ATTACHMENT 2 TO AEP:NRG:1182

EXISTING TECHNICAL SPECIFICATION PAGES
MARKED TO REFLECT PROPOSED CHANGES

ATTACHMENT 3 TO AEP:NRC:1182

PROPOSED
TECHNICAL SPECIFICATION PAGES

FIGURE 3.1-4

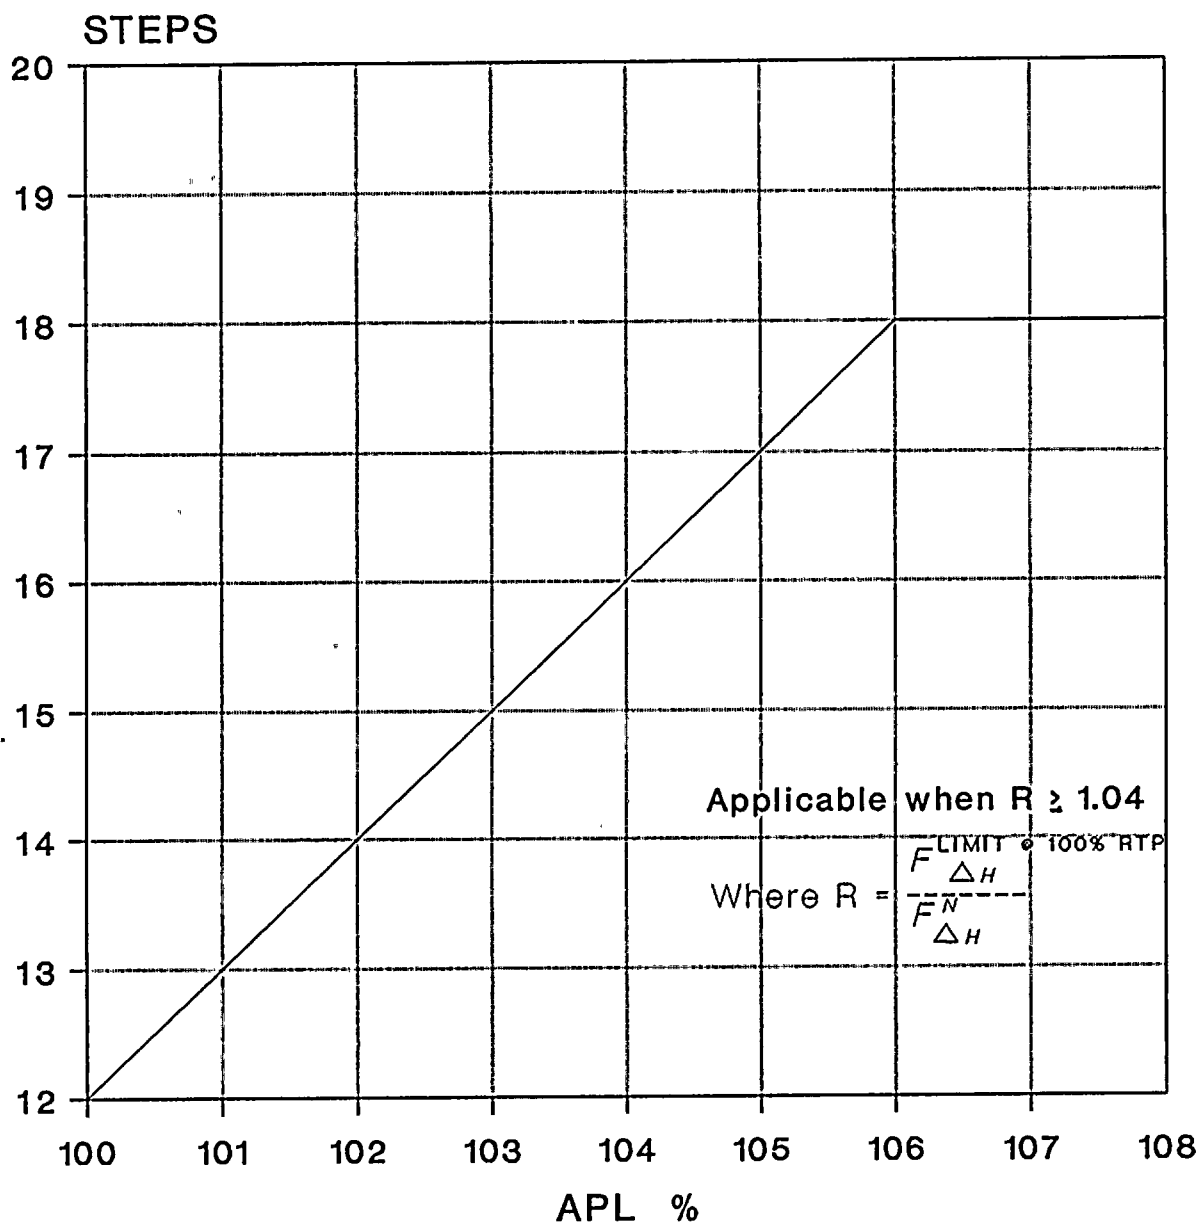
- o for THERMAL POWER less than or equal to 85% of RATED THERMAL POWER, the allowed rod misalignment is ± 18 steps, and
- o for THERMAL POWER greater than 85% of RATED THERMAL POWER, the allowed rod misalignment is ± 12 steps or as determined from Figure 3.1-4. Figure 3.1-4 permits for an allowed rod misalignment from ± 13 steps (for APL equal to 101%) to ± 18 steps (for APL greater or equal to 106%) provided the value of R (defined in Figure 3.1-4) is greater than or equal to 1.04.

4.1.3.1.3 The allowed rod misalignment for THERMAL POWER greater than 85% of RATED THERMAL POWER shall be determined in conjunction with the measurement of APL as defined in Specification 4.2.6.2.

FIGURE 3.1-4

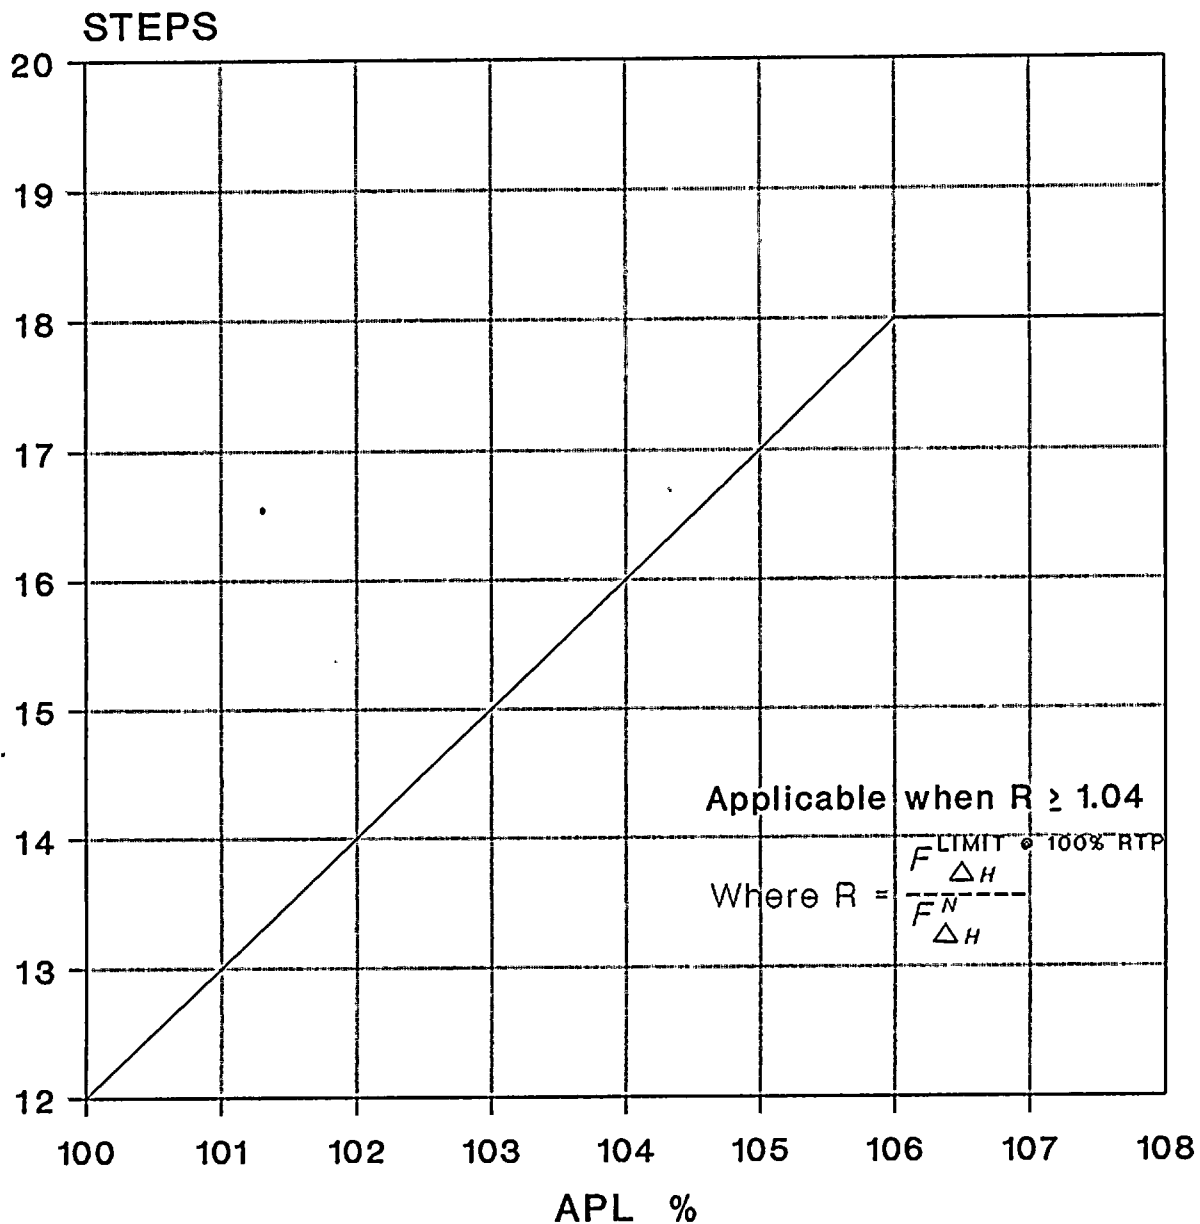
- o for THERMAL POWER less than or equal to 85% of RATED THERMAL POWER, the allowed rod misalignment is ± 18 steps, and
- o for THERMAL POWER greater than 85% of RATED THERMAL POWER, the allowed rod misalignment is ± 12 steps or as determined from Figure 3.1-4. Figure 3.1-4 permits for an allowed rod misalignment from ± 13 steps (for APL equal to 101%) to ± 18 steps (for APL greater or equal to 106%) provided the value of R (defined in Figure 3.1-4) is greater than or equal to 1.04.

4.1.3.1.3 The allowed rod misalignment for THERMAL POWER greater than 85% of RATED THERMAL POWER shall be determined in conjunction with the measurement of APL as defined in Specification 4.2.6.2.
